# UNITED STATES PATENT AND TRADEMARK OFFICE

APPLICATION NO.	FILING DATE	FIRST NAMED INVENTOR	ATTORNEY DOCKET NO.	CONFIRMATION NO.
10/760,253	01/21/2004	Kia Silverbrook	MPA15US	1566
24011 7590 08/15/2007 SILVERBROOK RESEARCH PTY LTD 393 DARLING STREET BALMAIN, 2041 AUSTRALIA			EXAMINER MARTIN, LAURA E	
			ART UNIT 2853	PAPER NUMBER
			MAIL DATE 08/15/2007	DELIVERY MODE PAPER

## Office Action Summary

**DETAILED ACTION**

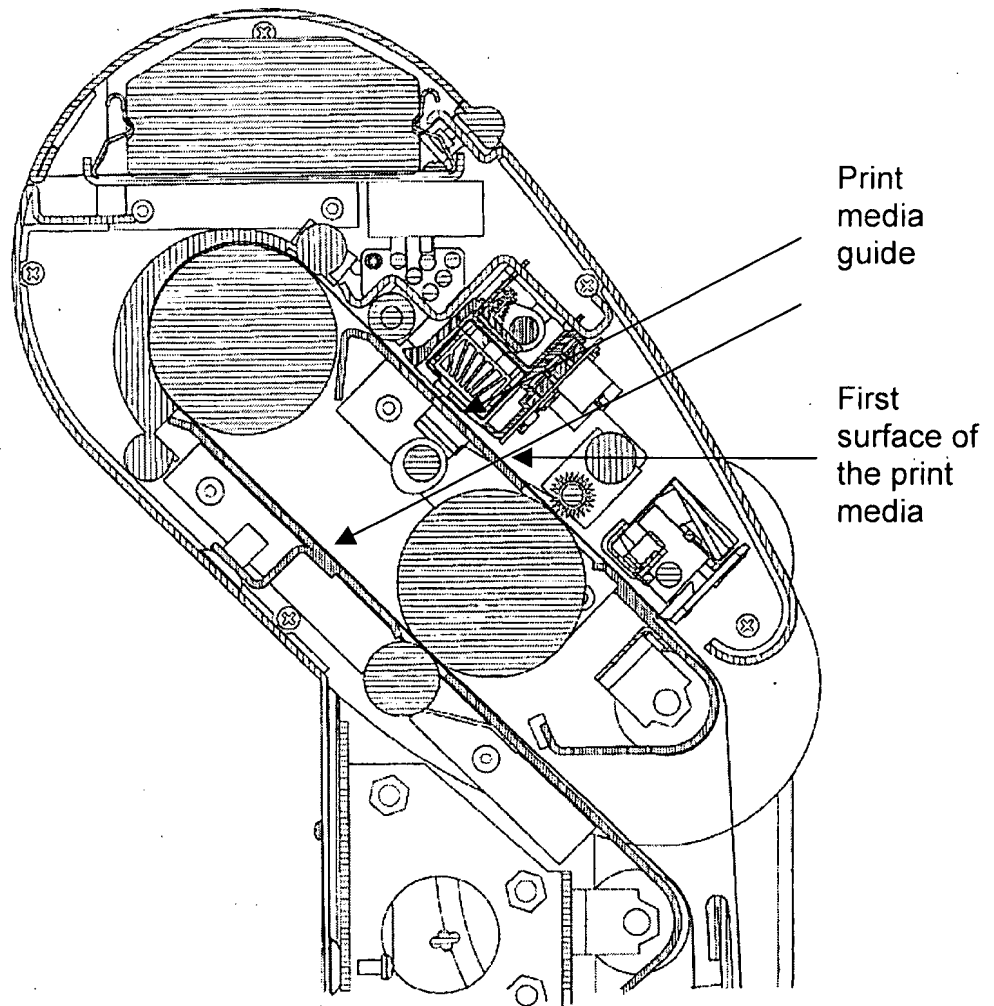
Silverbrook teaches a print media guide mounted to a slanted portion of the casing, adjacent the print surface, a slanted print media contact surface of the print media guide arranged to contact and guide the first surface of the print media over the print surface for printing onto the first surface (shown below).

Applicant's arguments filed 7/10/07 have been fully considered but they are not persuasive. Either side of the media could be the first surface; it is not clearly defined which surface is the first surface. As shown in figure 7, there is no contact between the paper and the nozzles (there is a small space between). Silverbrook (908) discloses a nozzle shield protecting the nozzles in column 3, lines 5-10. The paper would be guided or led over top of the nozzles, as the media would not be able to be guided into the nozzles. As shown in figure 7, the paper is guided between the printhead structure and a separate media guide.
